Arlington County Department of
Environmental Services
DES

**Construction Standard Details
2020**

**Update #1
February 2023**

The following Standard Details are modified or added to the 2020 DES Construction Standard Details:

1	10/7/2021
ISSUED	9/14/2020
DRAWING NO.	
R-3.3

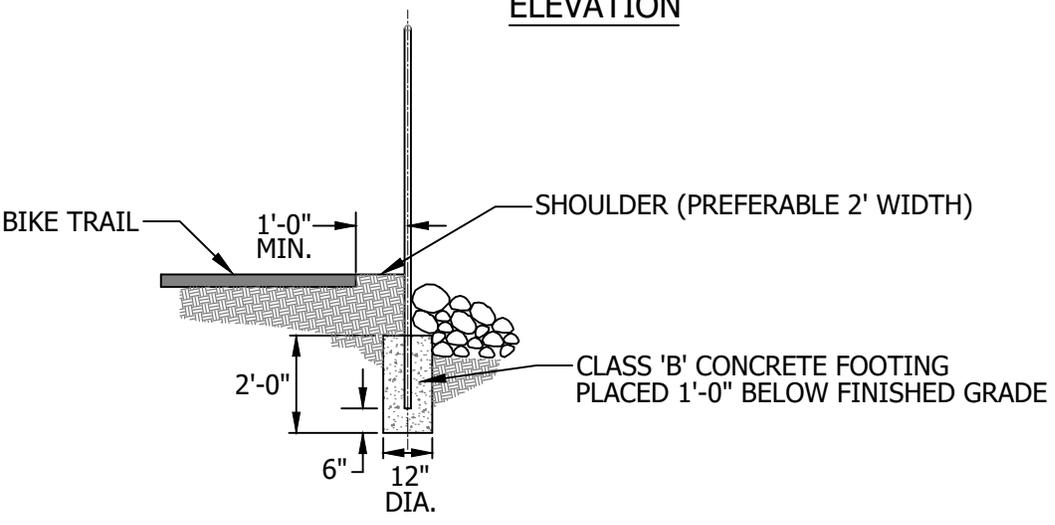
Detail R-3.3 Trail Railing [*Modification*]

- Removed Numbered Notes

DRAWING NO.
R-4.0

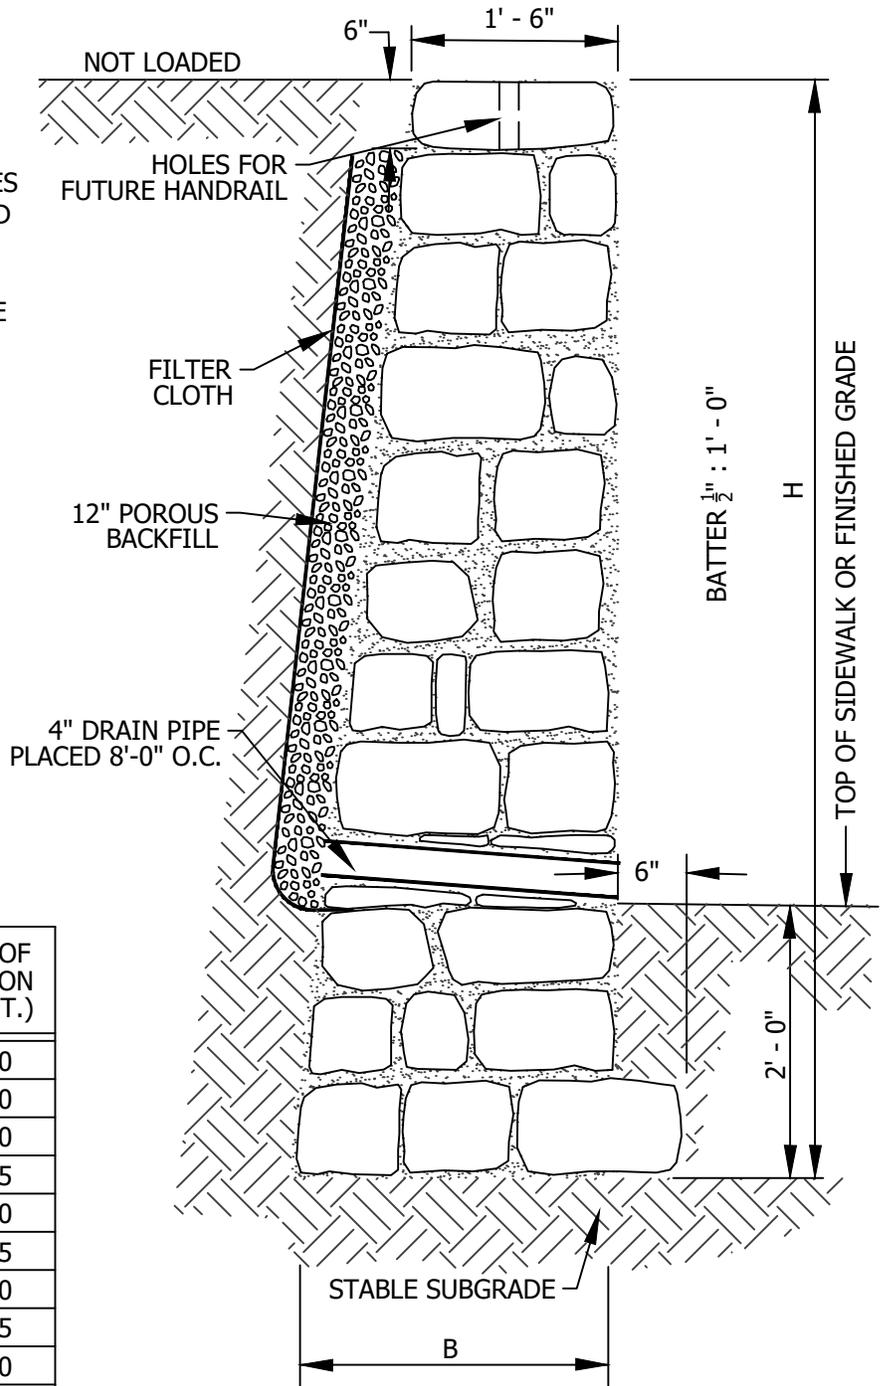
Detail R-4.0 Mortar Rubble Retaining Wall Level Backfill [*Modification*]

- Removed Reference “(For Def., See Drawing R-1.0)”

DRAWING NO.
R-4.1

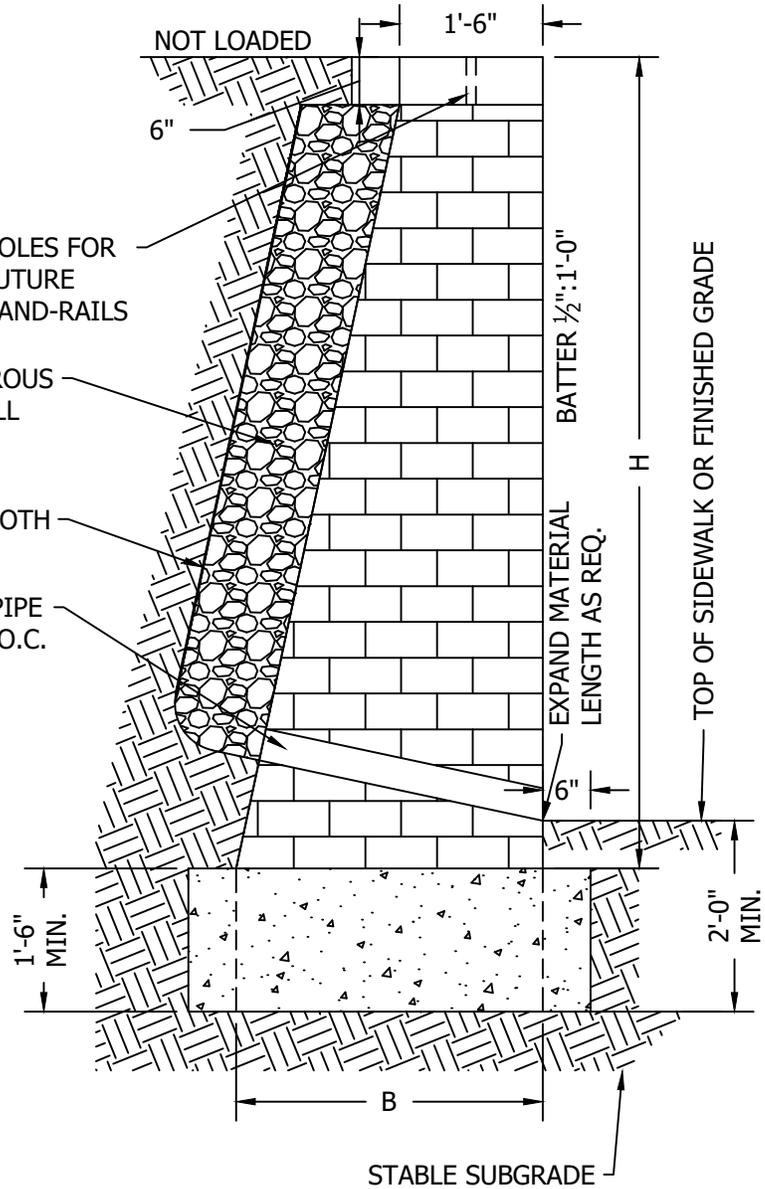
Detail R-4.1 Mortar Rubble Retaining Wall with Concrete Base, Level Backfill
[*Modification*]

- Removed Reference “(For Def., See Drawing R-1.0)”

DRAWING NO.
R-4.2

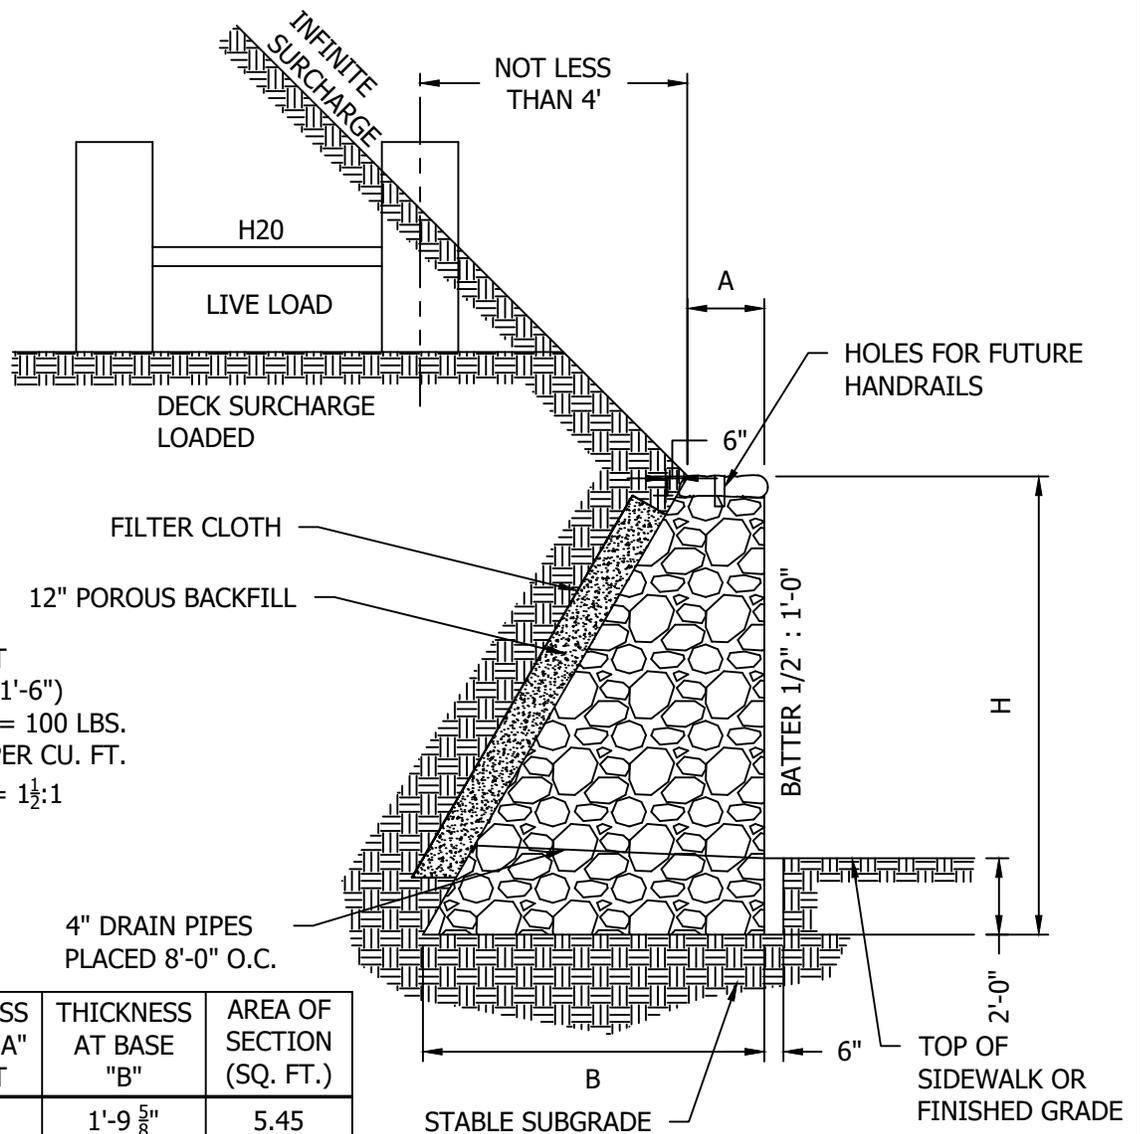
Detail R-4.2 Mortar Rubble Retaining Wall Infinite Surcharge or Deck Surcharge
[Modification]

- Removed Reference “(For Def., See Drawing R-1.0)”

DRAWING NO.
D-3.4

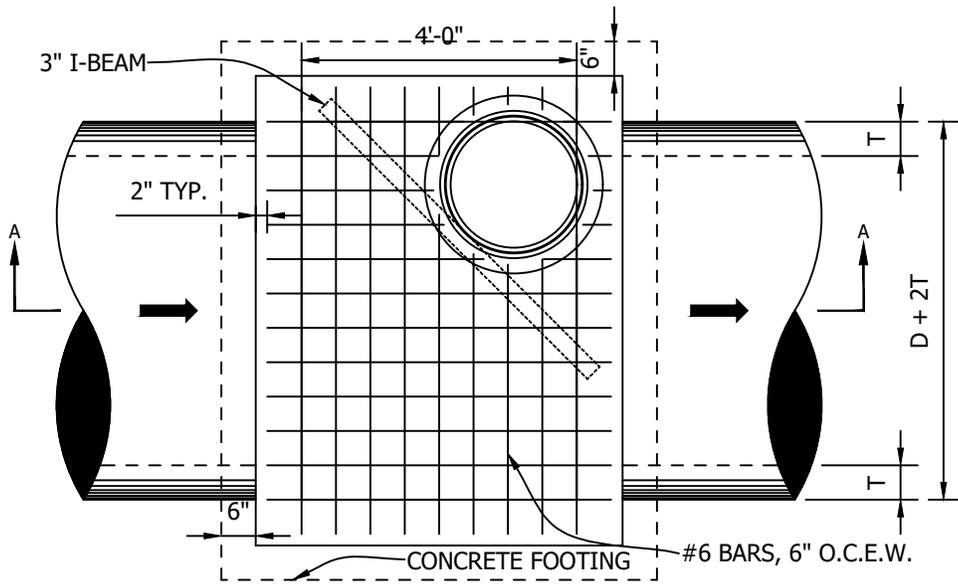
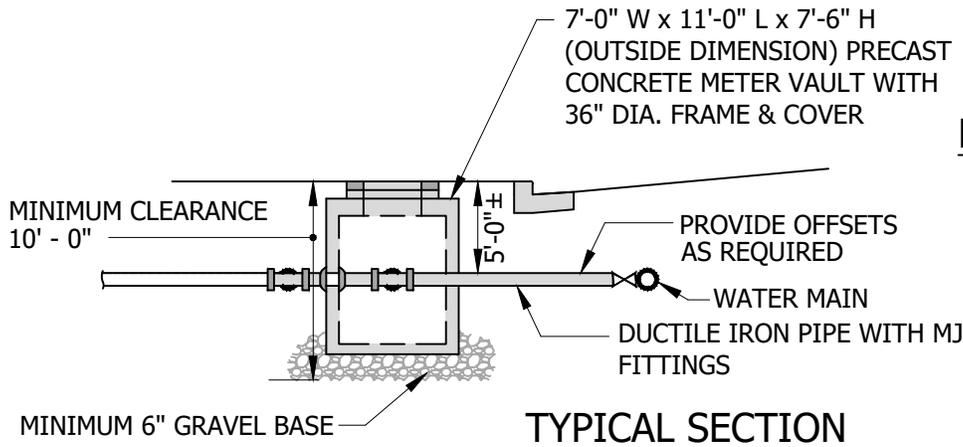
Detail D-3.4 Storm Sewer Manhole, MH-3 For Pipe Sizes Greater than 54” [Modification]

- Updated Reference Number from “M-3.4” to “D-3.4”

DRAWING NO.
W-8.2

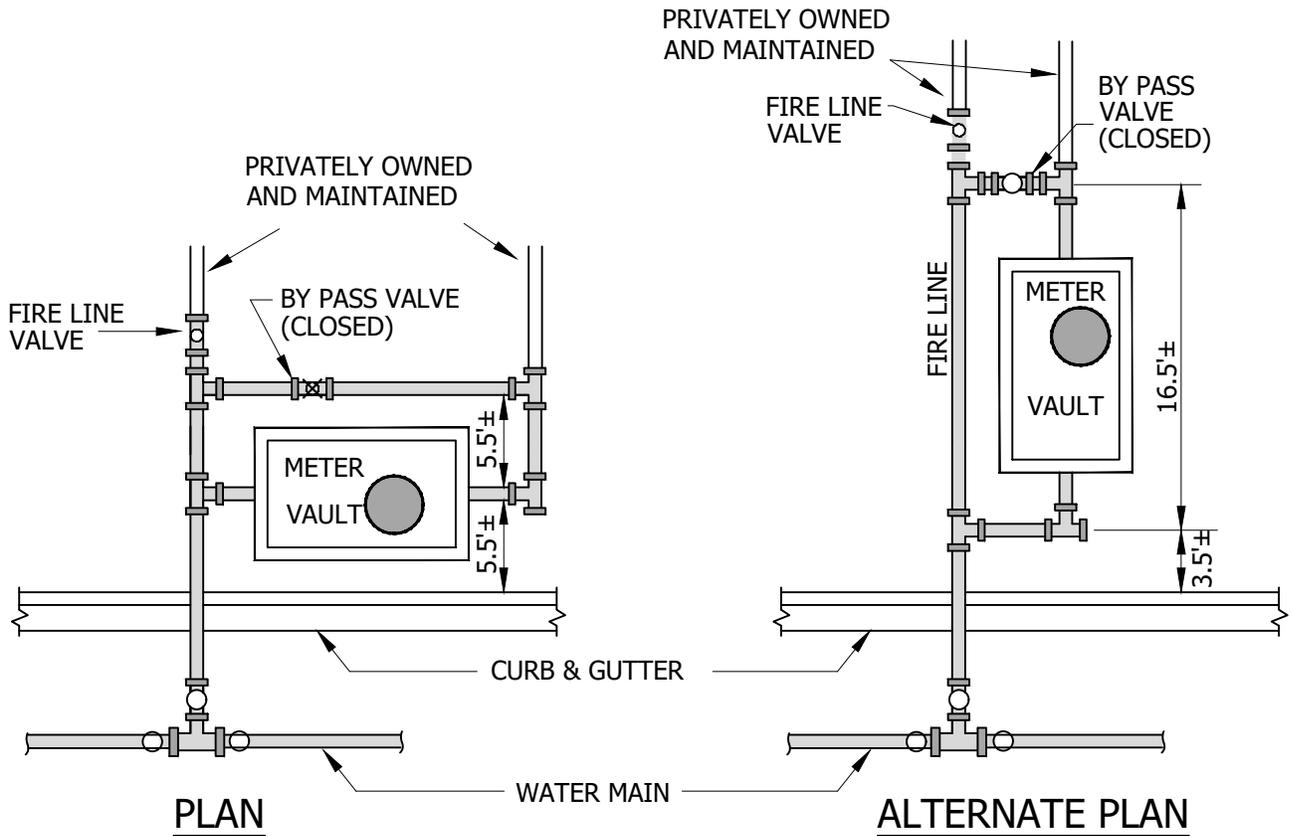
Detail W-8.2 Water Service Connections 6 Inch and 8 Inch by Developer [Modification]

- Number Change
- Changed Number from M-8.2 to W-8.2

1	2/28/2023
ISSUED	9/14/2020
DRAWING NO.	
W-9.3

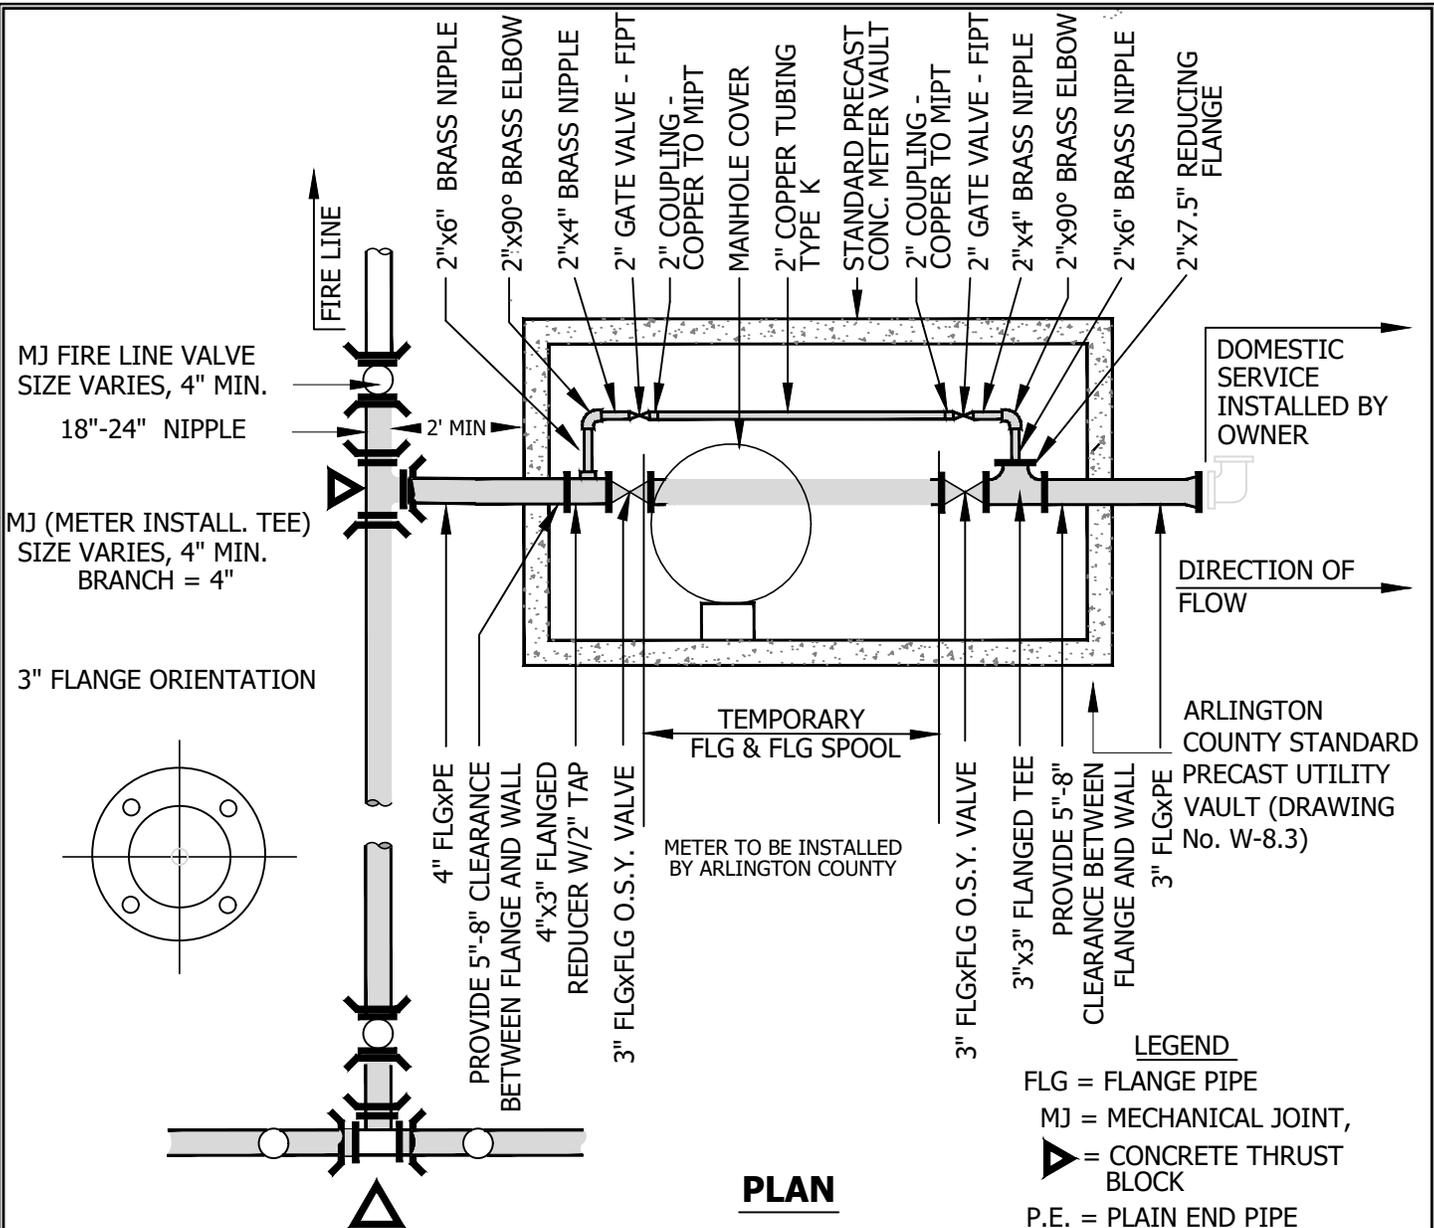
Detail W-9.3 3 Inch Water Service by Developer [Modification]

- References to “F” changed to “FLG”
- Reference to MEGALUGS removed from Note 4
- Concrete Thrust Blocks are darker

1	2/28/2023
ISSUED	9/14/2020
DRAWING NO.	
W-9.4

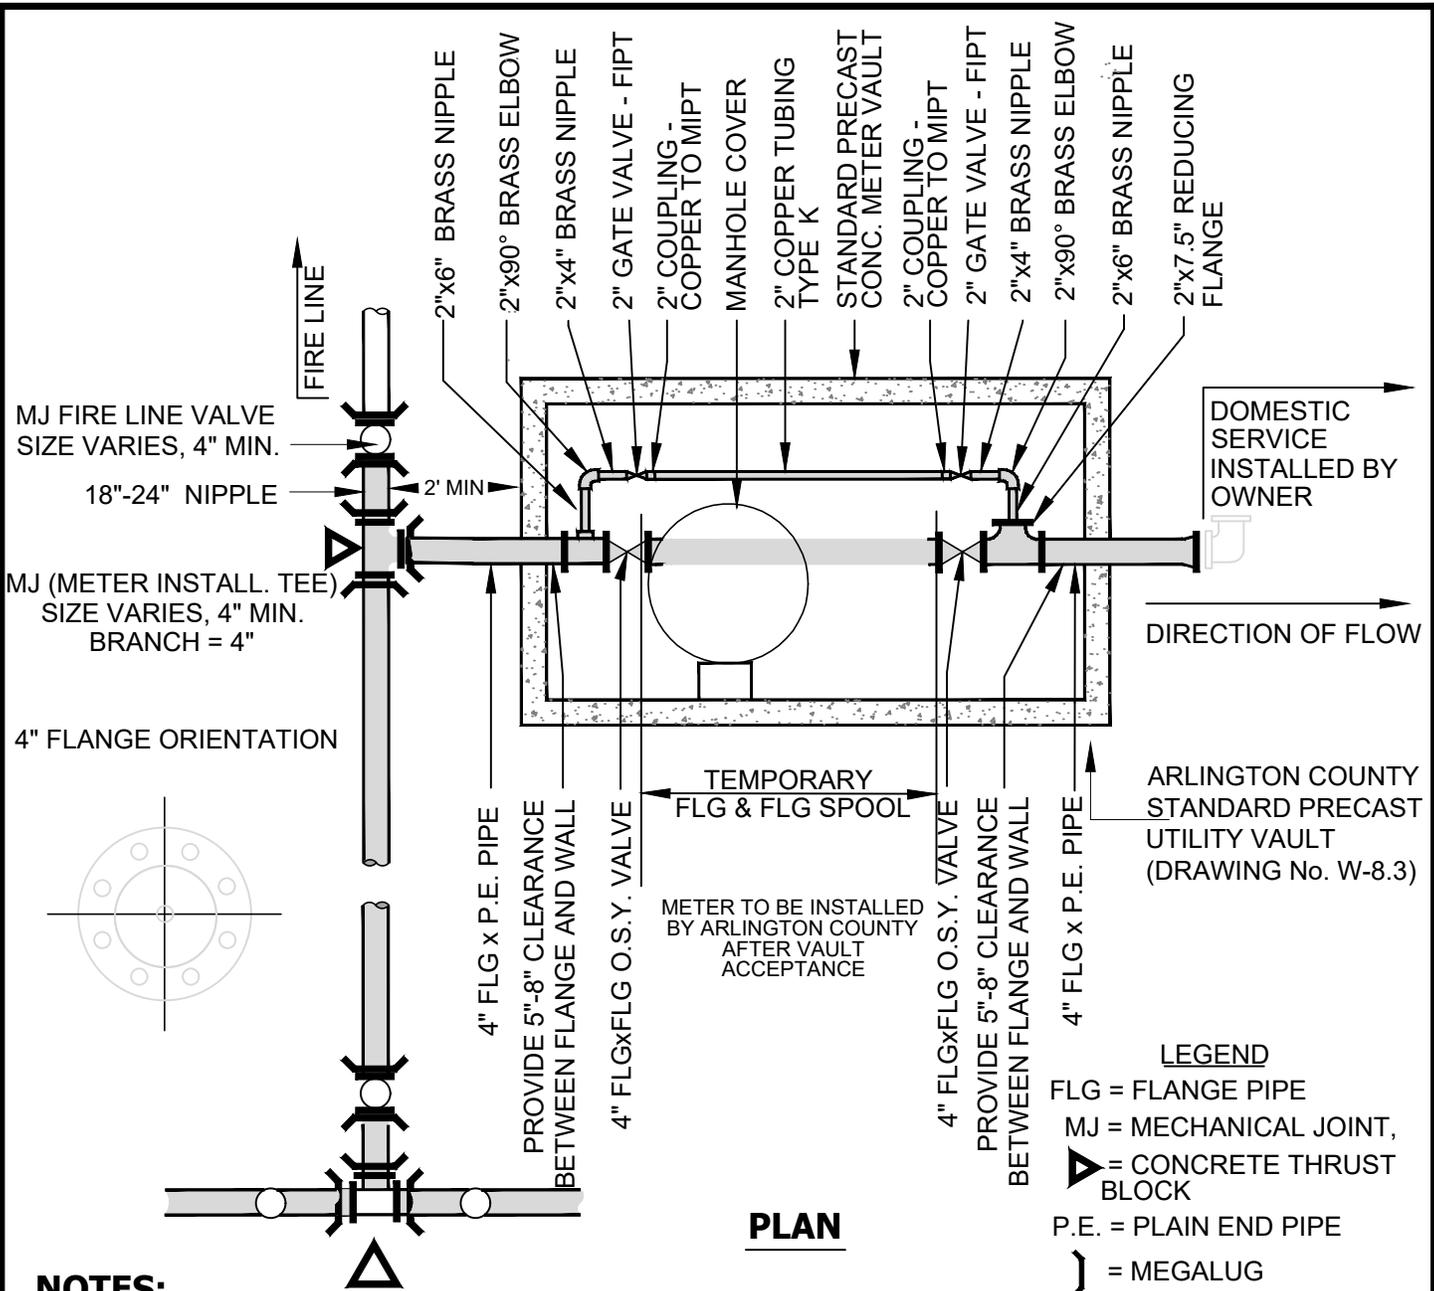
Detail W-9.4 4 Inch Water Service by Developer [Modification]

- Title Updated to Read “4 Inch Water Service by Developer”
- References to “F” changed to “FLG”
- Reference to MEGALUGS removed from Note 4
- Note 6 Updated to replace ‘3” FLG’ with ‘4”FLG’
- Concrete Thrust Blocks are bolder
